GOOD SAMARITAN HOSPITAL

1ST FLOOR START ROOM ASI #2

Fire Alarm and Detection System

FIRE ALARM SYSTEM
TITLE SHEET
GOOD SAMARITAN HOSPITAL
EAST/NORTH WING
407 14TH AVENUE
PUYALLUP, WA

APPROVED BY: EP
DRAWN BY: JCP
DATE: 6-21-2001
SITE NUMBER: 459
SHEET NUMBER: FA-F-01N

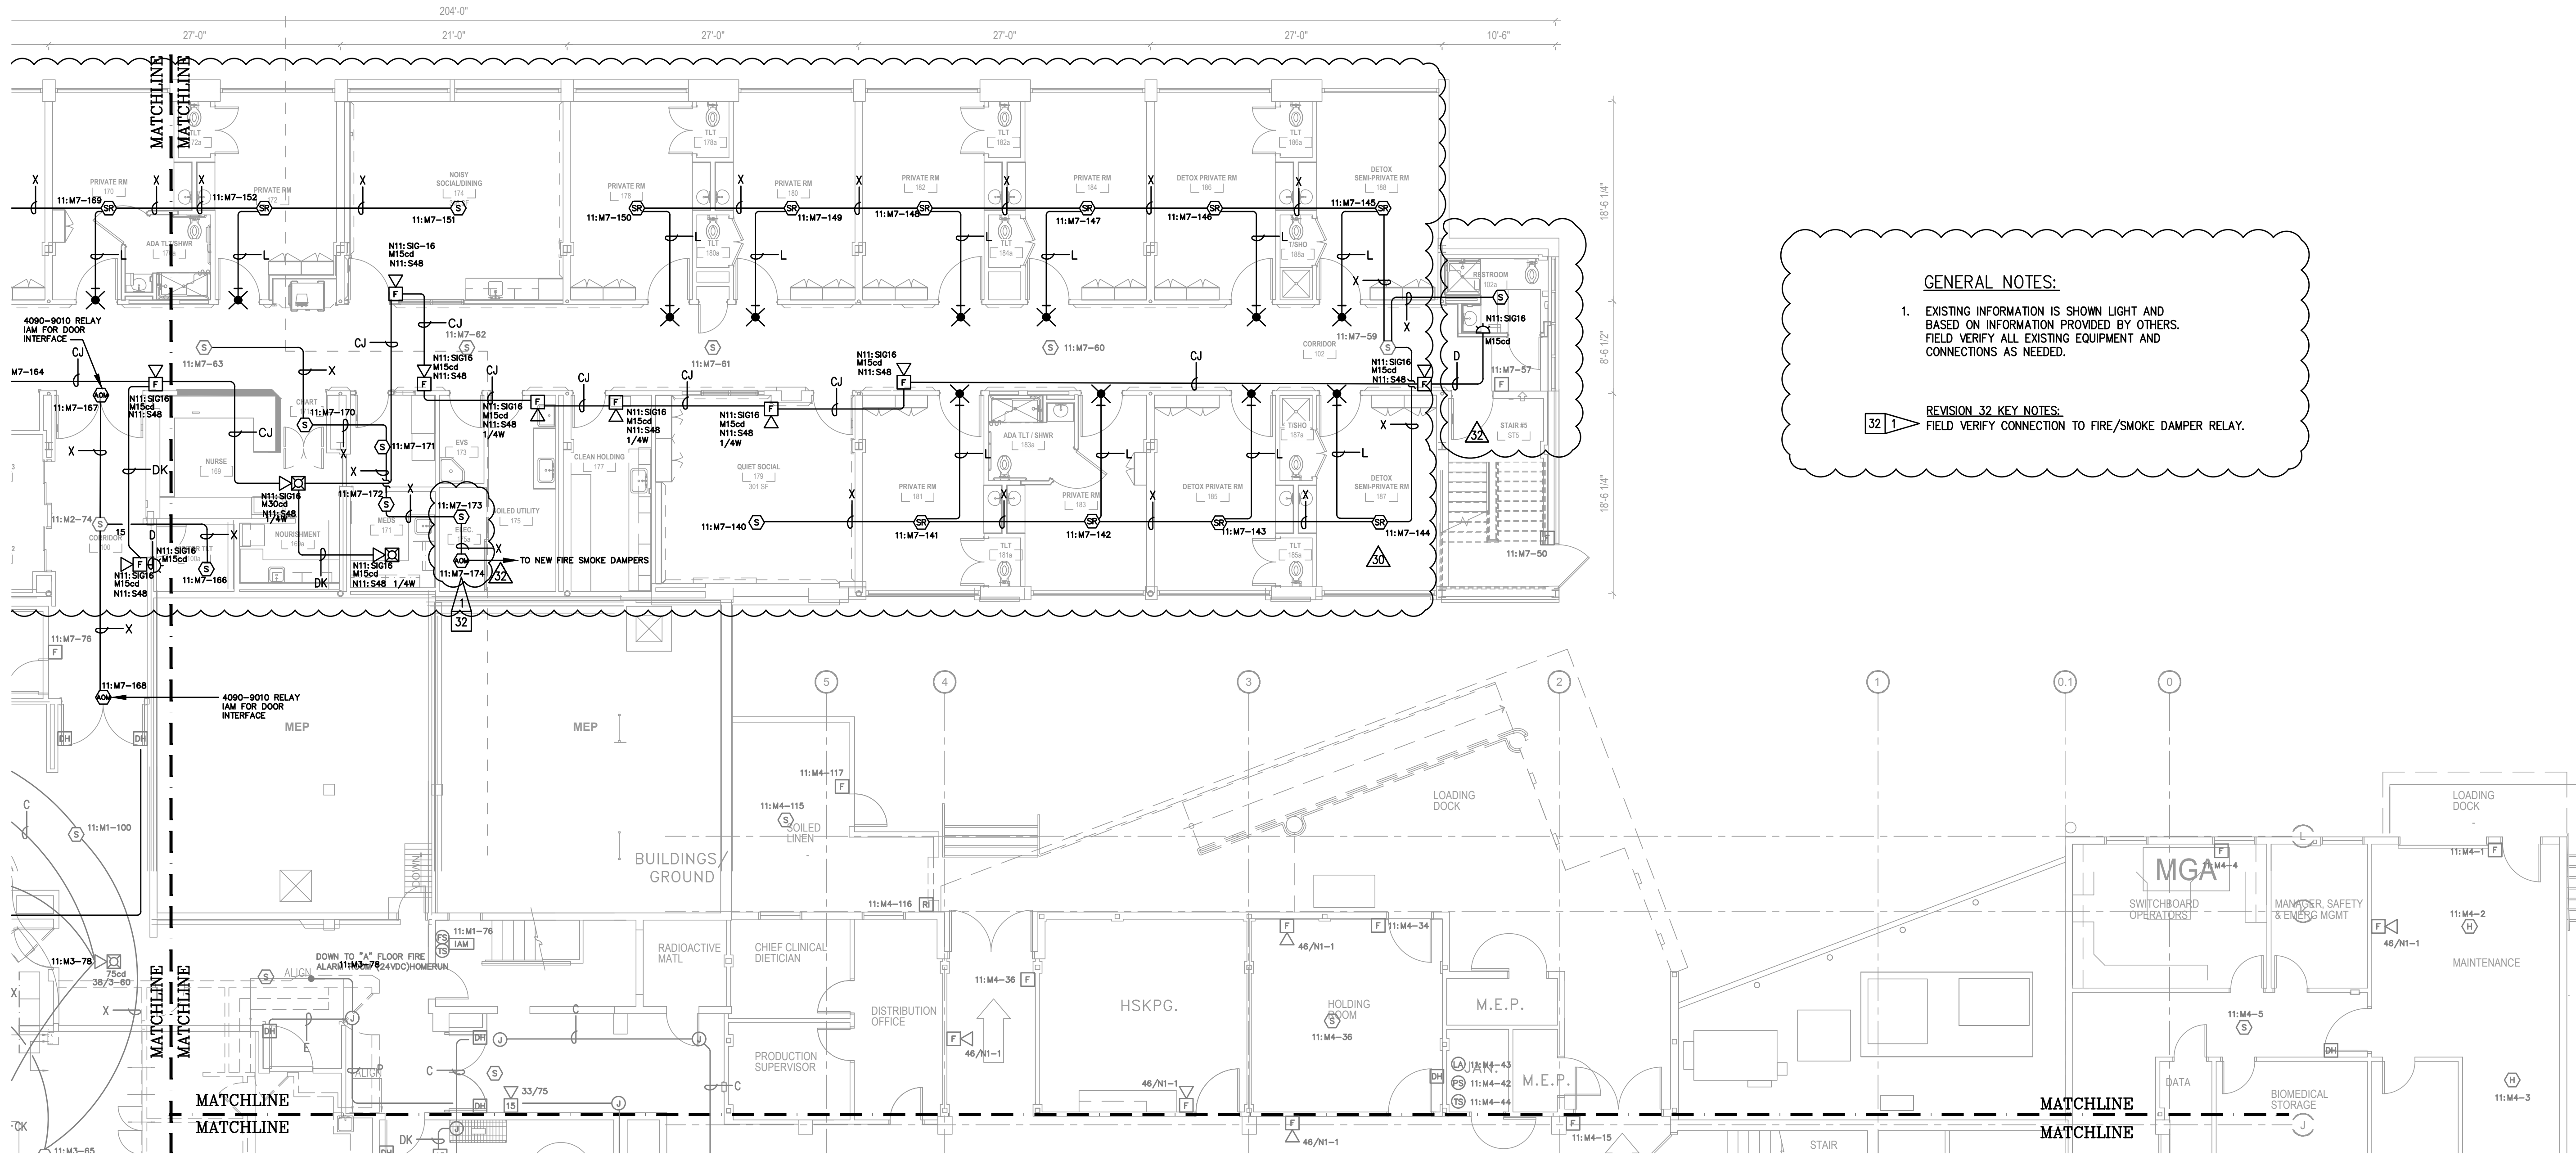
REVISION 32 KEY NOTES:
FIELD VERIFY CONNECTION TO FIRE/SMOKE DAMPER RELAY.
